Comments By Gregory Yount

Manager: The NAU Project, LLC

Chapter One and Two

Page 2-16 and Figure 2.4-4

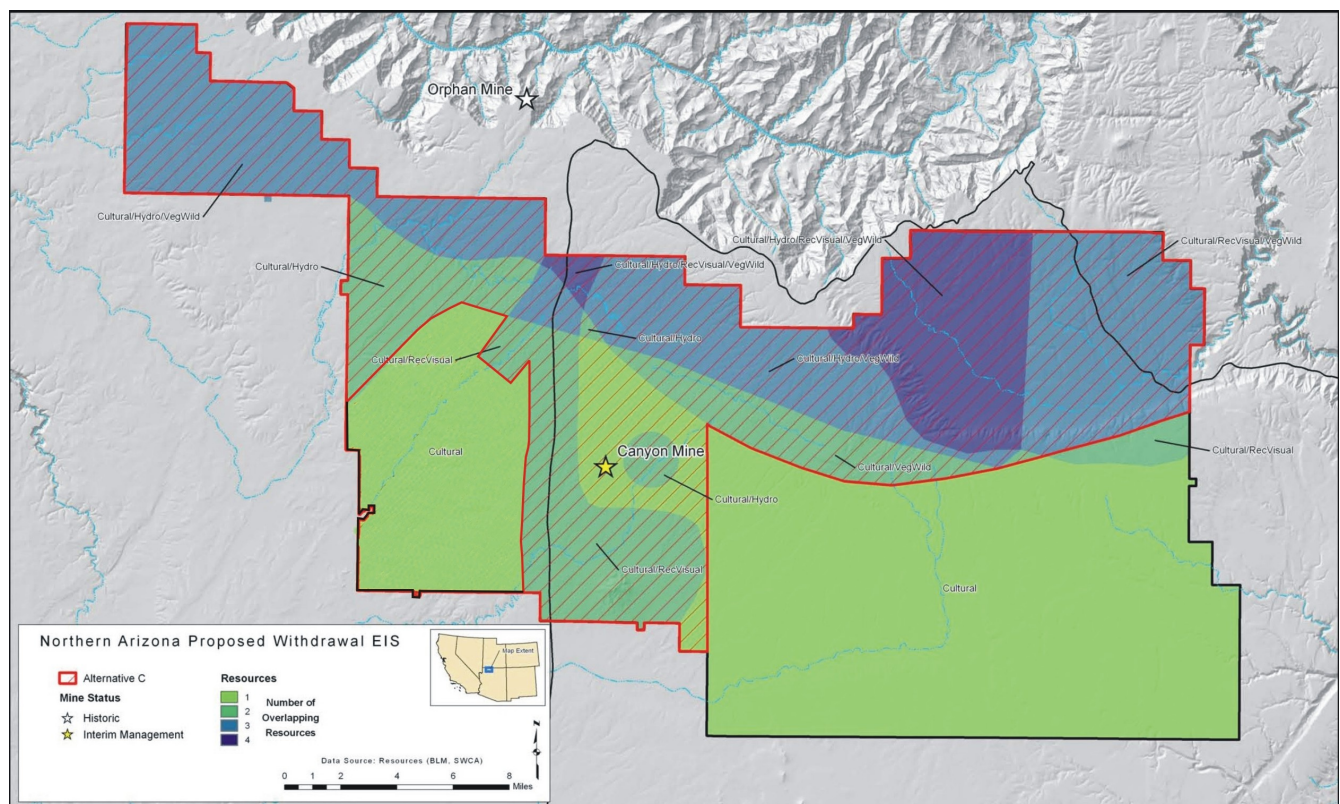
The Alternative C for the South Parcel is too restrictive. The area in the Southwest corner of the parcel has the same "values" as the area that is open East of Highway 64 and Red Butte. The area West of Hwy 64 that is only marked "Cultural" should be open for mineral entry under Alternative C. That this area is closer to Havasu Spring should have no bearing as the Water Resource section of this DEIS calculated no or negligible impacts at Havasu Springs from mining development. The Alternative C map should look like:

Alternative C is too restrictive for the South Parcel. Both of the areas in the above figure that are now indicated as open are equivalent. There is no reason to remove the West parcel as was done in the current Alternative C.
